AltoUpdate...

MAKE	TRANSMISSION	APPLICATION	YEAR
General Motors	700R4, 4L60, 4L60E	Rear Wheel Drive GM	89-On

Reuse Your Existing Drum with Our #057758 Wave Spring and Spacer Plate Kit...

Kit #057758 Contents

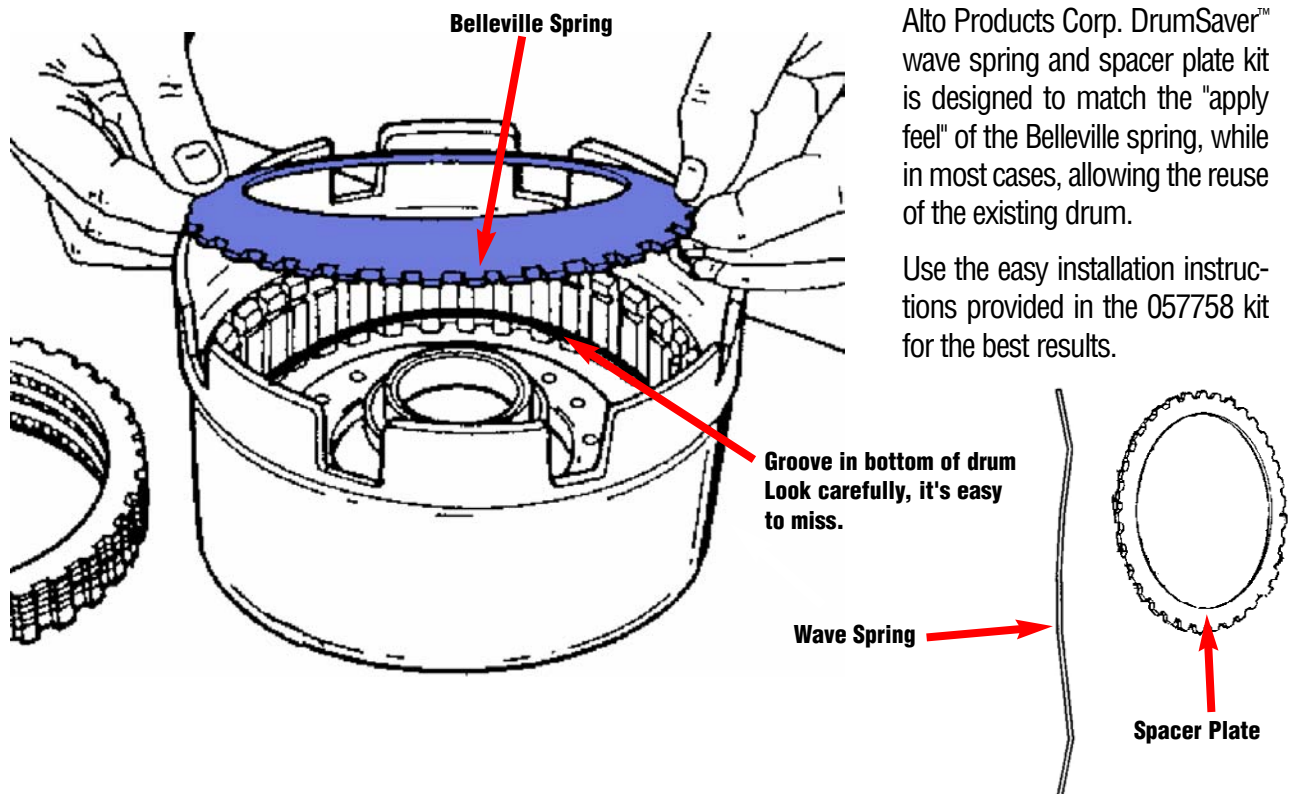
The Belleville spring located in the bottom of the reverse input drum flexes and displaces large amounts of metal. The metal is moved throughout the transmission accelerating the wear of bushings, bearings, planetary pinions, and the valve body. The Belleville spring may also catch in the groove and cause a delayed reverse engagement.

Alto Products Corp. DrumSaver™ wave spring and spacer plate kit is designed to match the "apply feel" of the Belleville spring, while in most cases, allowing the reuse of the existing drum.
